MFN 06-268

Docket No. 52-010

**Subject: Response to Portion of NRC Request for Additional Information  
Letter No. 43 Related to ESBWR Design Certification Application –  
ESBWR Containment Design and Probabilistic Risk Assessment Re:  
Containment Fragility Analysis – (Release A) RAI Numbers 6.2-95,  
6.2-97, 19.2-41, 19.2-44 to 19.2-46, 19.2-49, 19.2-50 and 19.2-57**

**Partial Response to NRC RAIs 6.2 and 19.2 Release A  
RAI 6.2-95, -97. 19.2-41, -44,-45, -46, -49, -50 and -57**

Figure 6.2-95(1). Nodal Locations

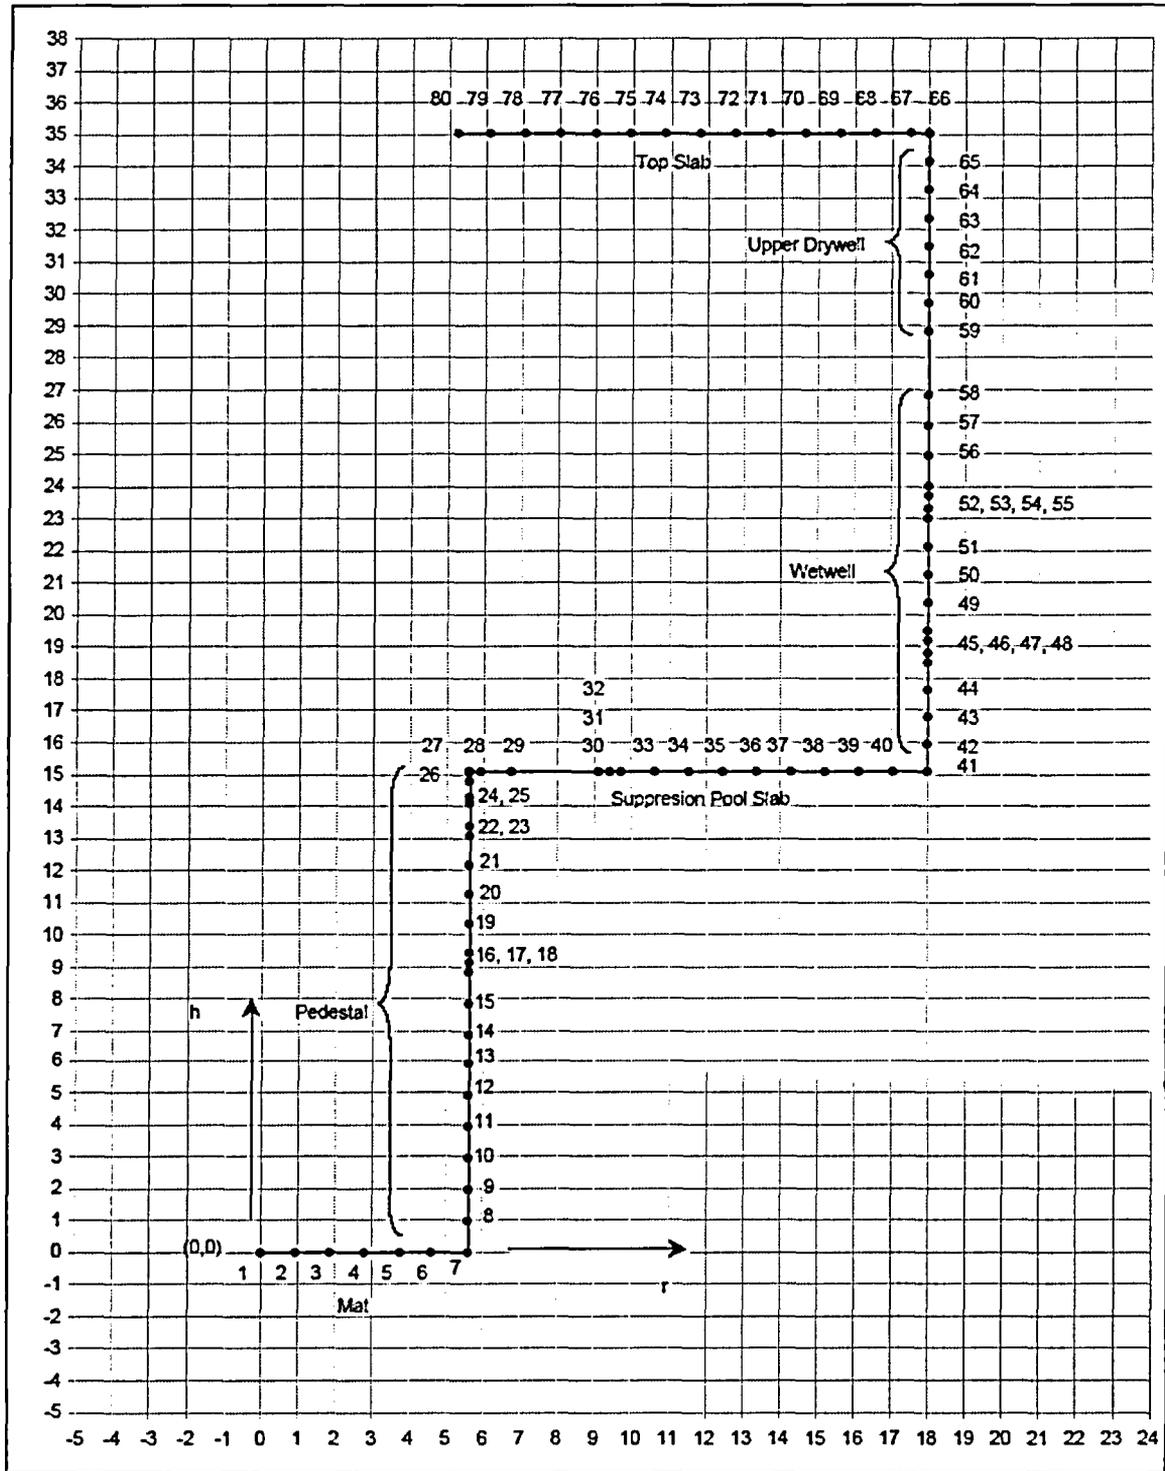
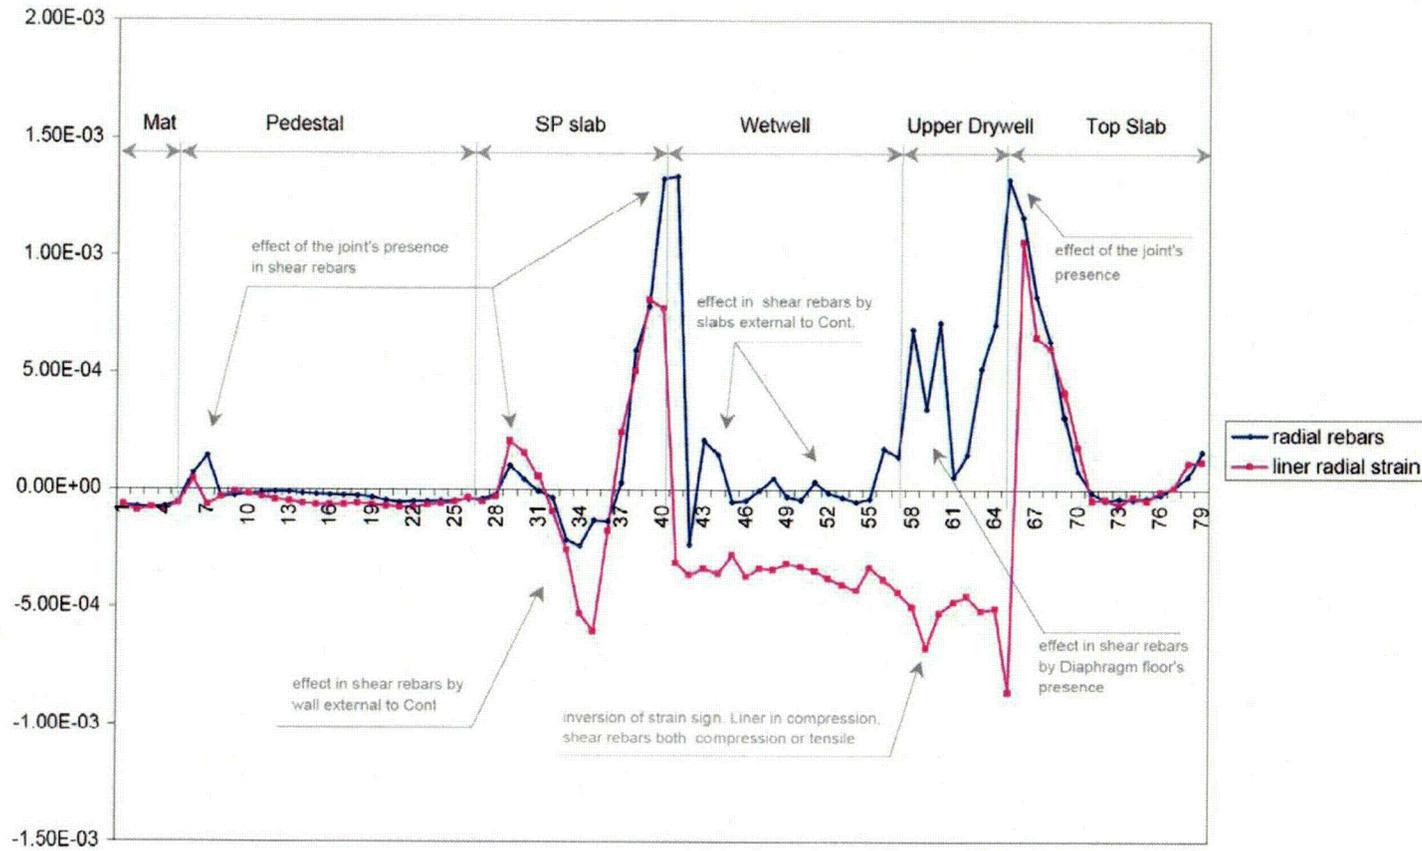
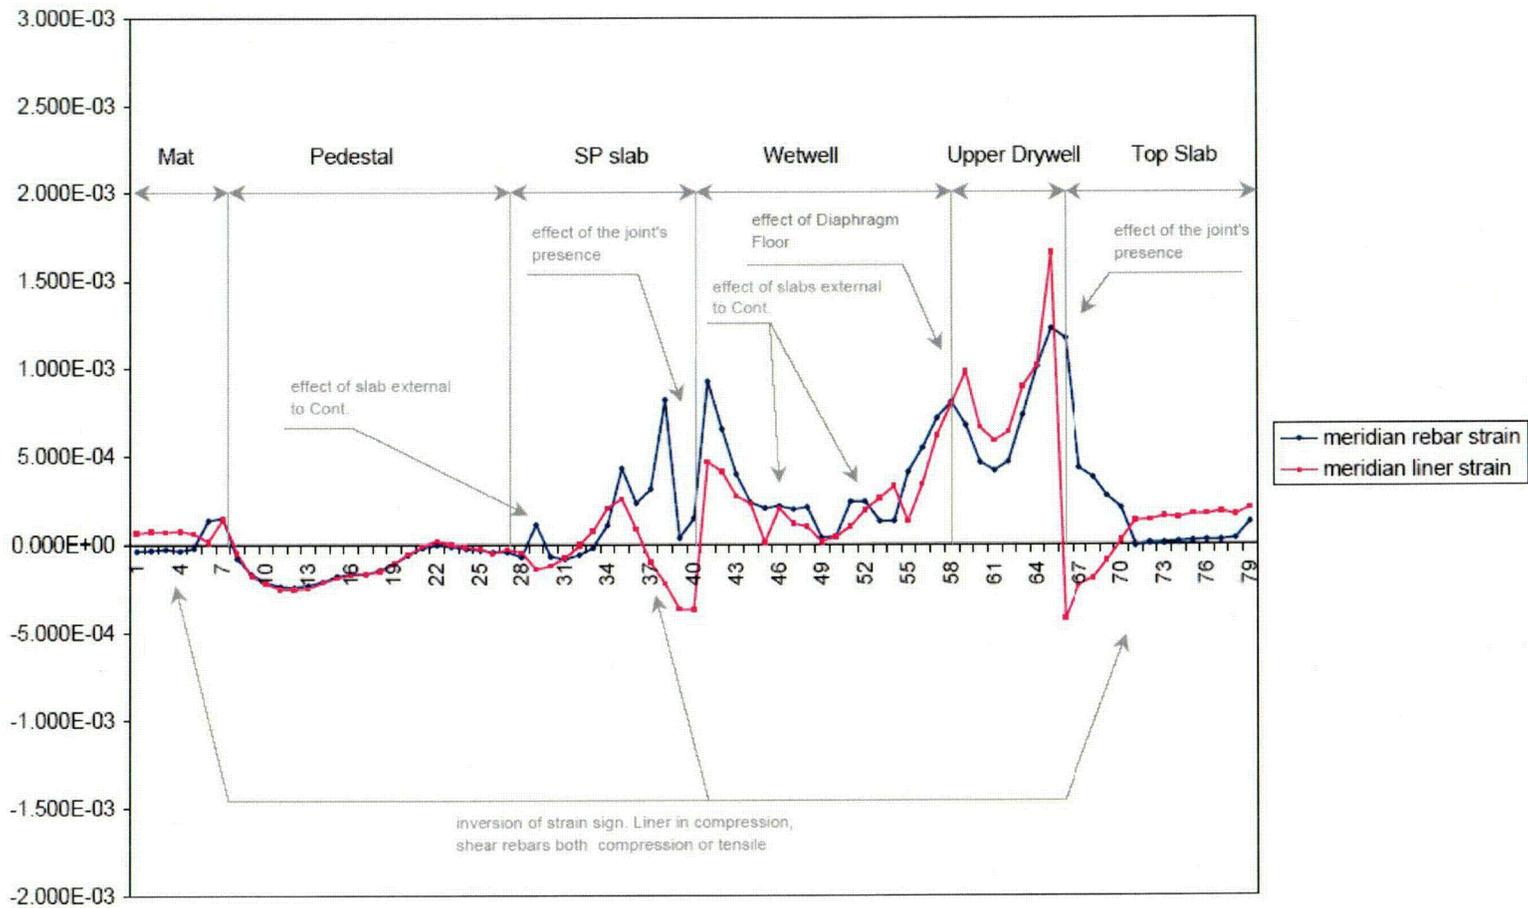
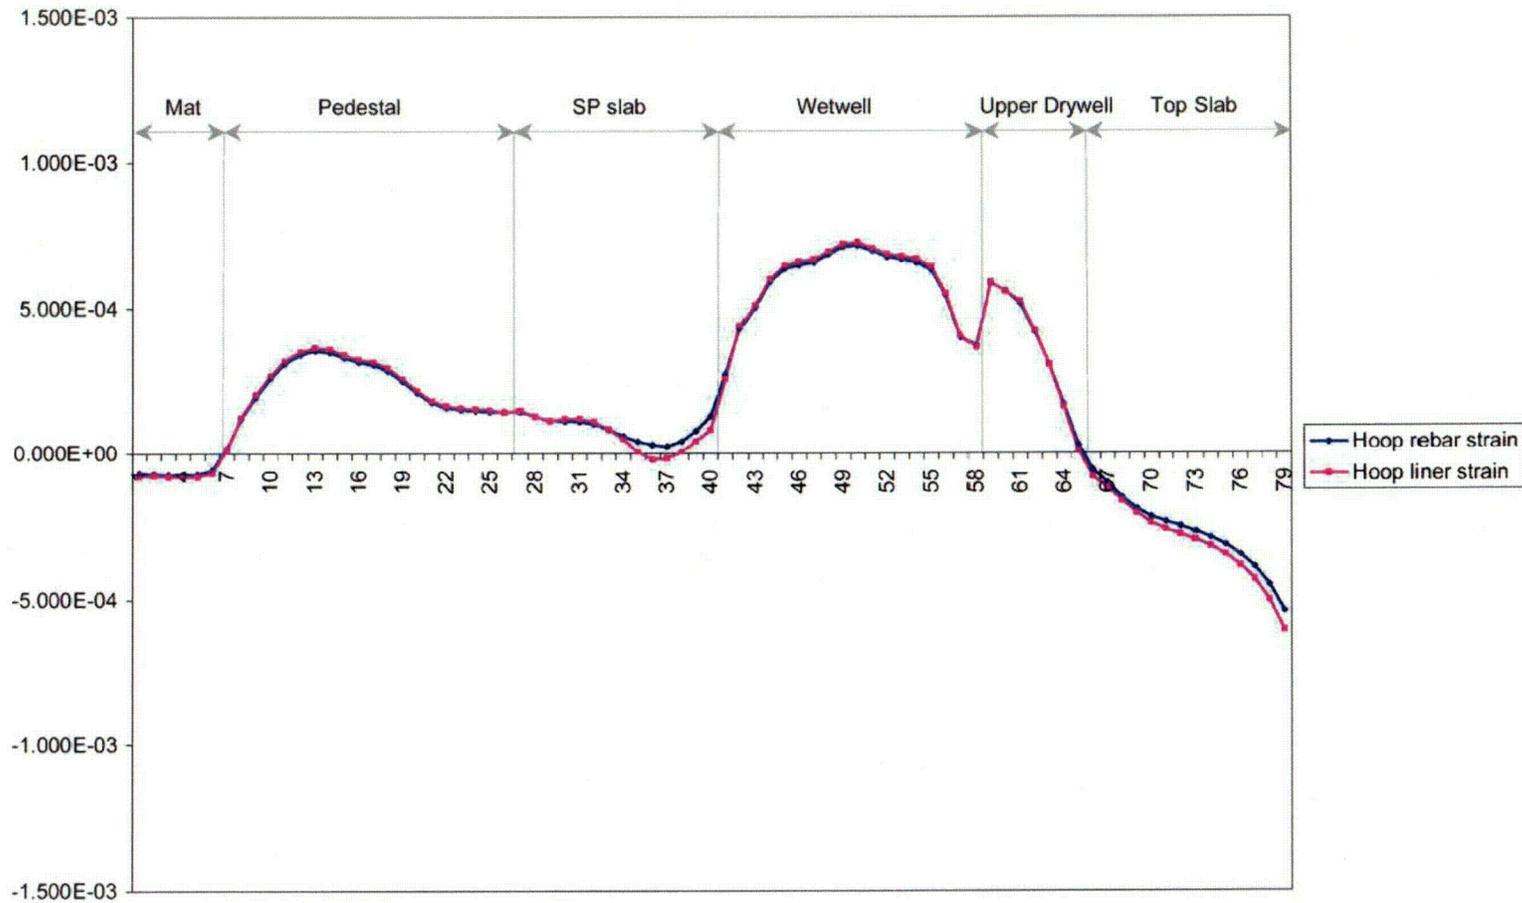
- a) Comparison of the concrete and rebar stresses to their factored load allowables.*
- b) Of the liner, concrete, and rebar, which limits the Level C pressure capability of the concrete containment (ignoring the steel penetrations)?*
- c) Compare the rebar strains to the liner strains at the 1.468 MPa load level. Explain any significant differences between the two.*
- d) The spacing between the anchors for the liner plate, including drawings to show how the liner is anchored into the concrete.*
- e) Locations (typical) of the heat affected zone at the liner weld seams and the proximity to liner anchors.*

- c) Figures 6.2-95(2), (3) and (4) show a comparison of the liner strains and rebar strains for concrete elements in contact with the liner in the radial, meridian and hoop directions, respectively, along the nodes shown in Figure 6.2-95(1). There are no significant differences between them if the rebars belong to a plane parallel to that of the liner. The comparison of the vertical shear rebar strains to the vertical liner strains (mat, SP slab or Top Slab), as well as of the radial shear rebar strains to the radial liner strains (Pedestal, Wetwell or Drywell) shows some differences. The explanation lies in how the load is being resisted, mainly, by bending and shear of

those structural elements. The shear stress distribution in shear rebars is therefore slightly different from that of the liner

Accordingly, the liner is mostly compressed in those areas, whereas the rebars can be under tensile or compression stress.

Other effects such as the proximity to the joint between structural members, as well as the presence of slabs, cause additional local differences. Note that, in spite of the differences, all rebar and liner strains are of the same order.

As for the hoop strain comparison, since none of the previous factors are present, liner and rebar deform in a consistent manner, such that there are not significant differences between them.

Figure Att. 19.2-44(2) McNeice slab

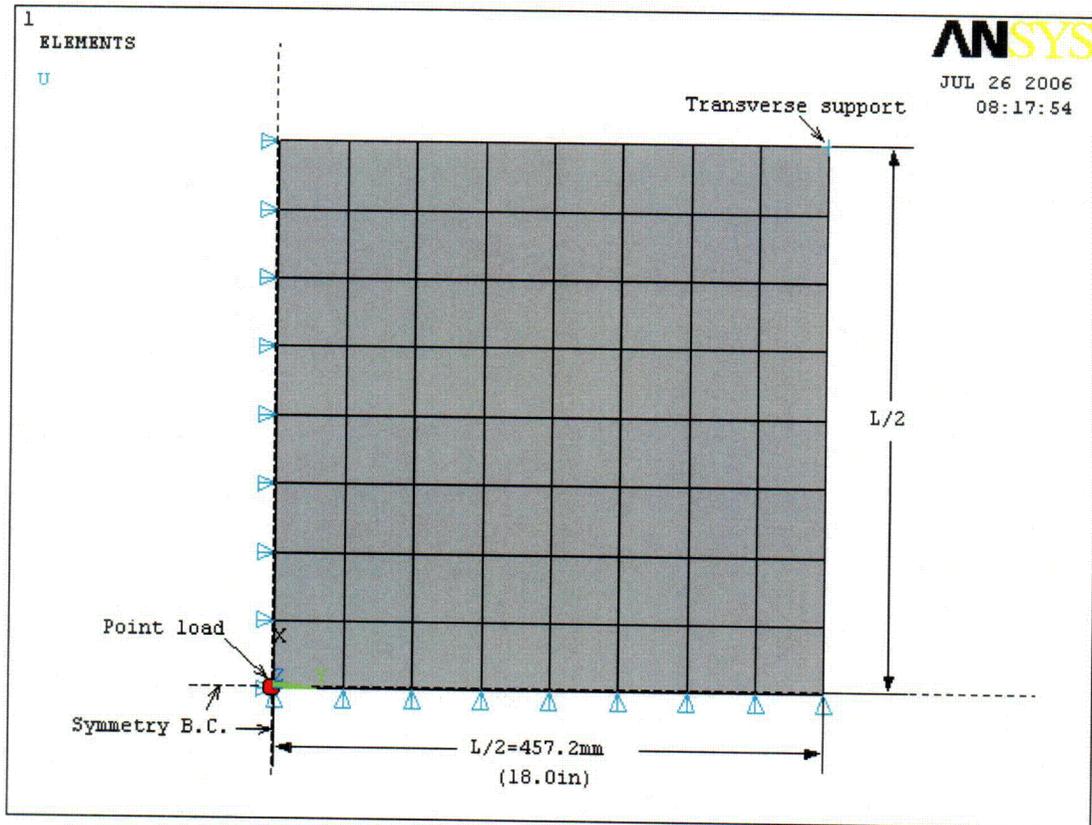
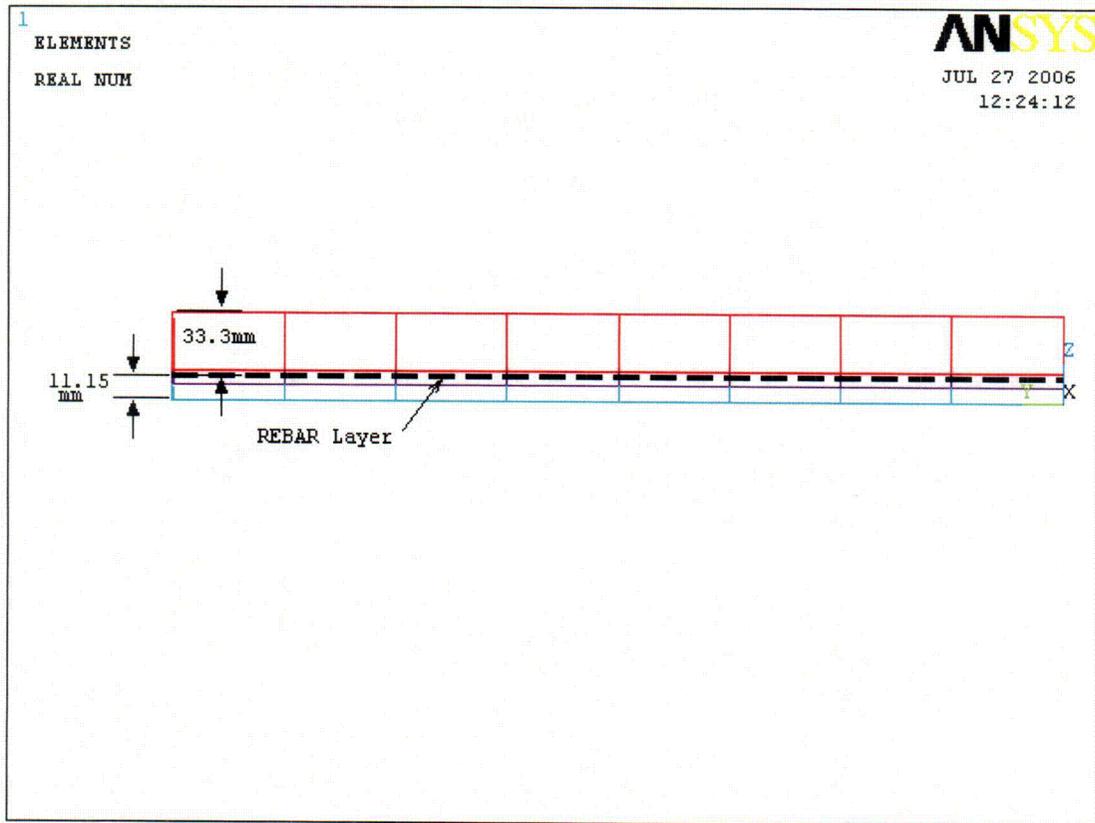
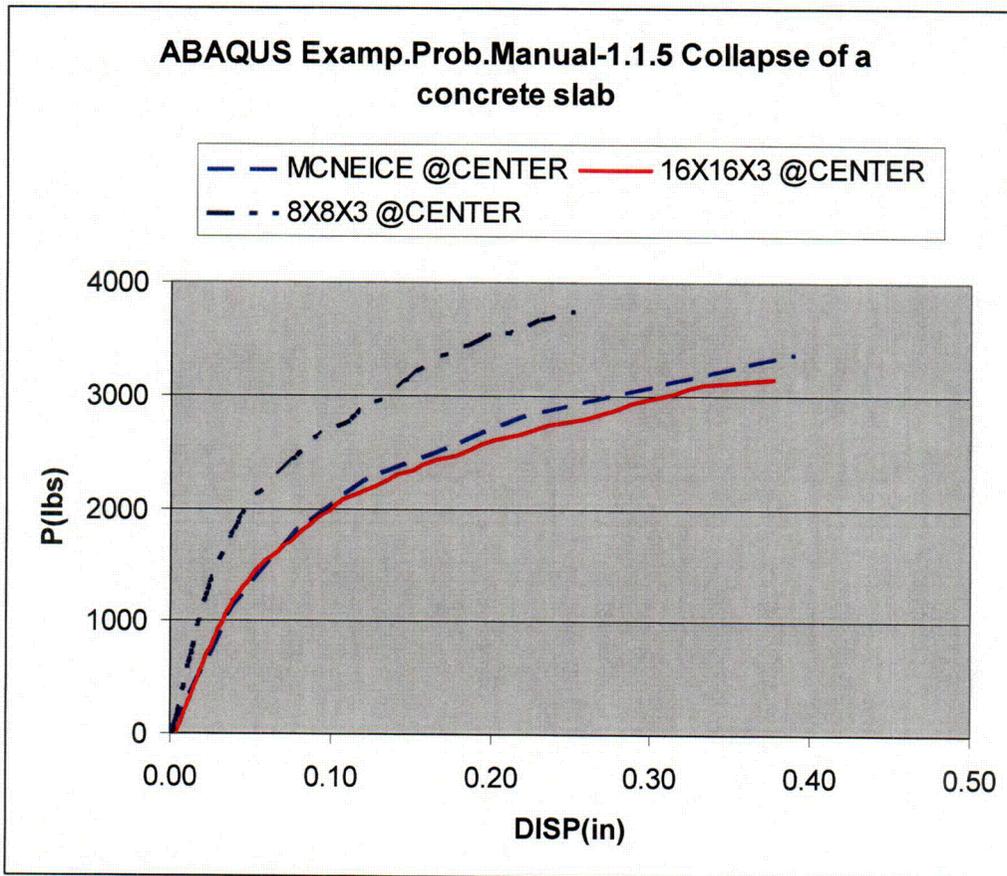
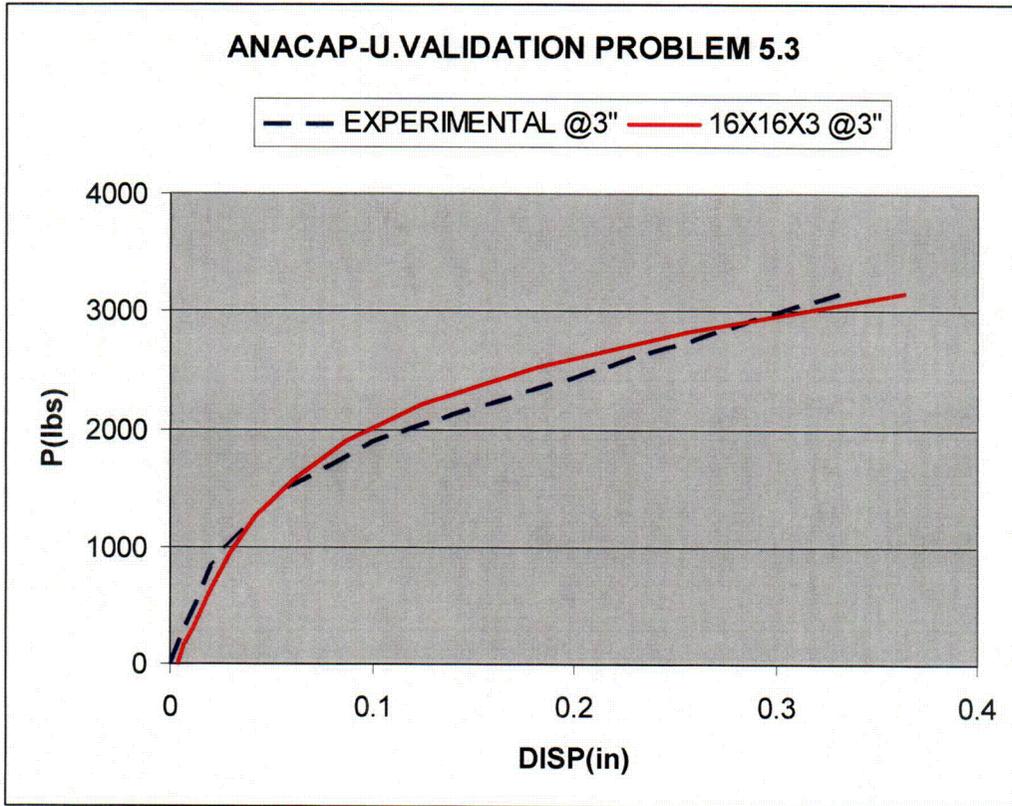
- c) the validation of the ANSYS reinforced concrete material model against other known commercial codes, such as ANACAP or ABAQUS, etc., on similar structures and loading, and their analysis comparisons;*

Two mesh sizes, 8x8x3 and 16x16x3, are considered. Figures 19.2-44(2) and 19.2-44(3) show the 8x8x3 mesh.

Figure Att.19.2-44(4) shows the load-deflection curve at the centre of the McNeice slab and the ANSYS results for both 8x8x3 and 16x16x3 mesh models. A very good agreement is reached with the 16x16x3 mesh. The 8x8x3 mesh over-predicts the stiffness of the test model.

Figure Att. 19.2-44(5) shows the load-deflection curve at a 3" offset along symmetry axe from origin of the McNeice slab and the ANSYS results for 16x16x3 mesh model. Also a very good agreement is observed.
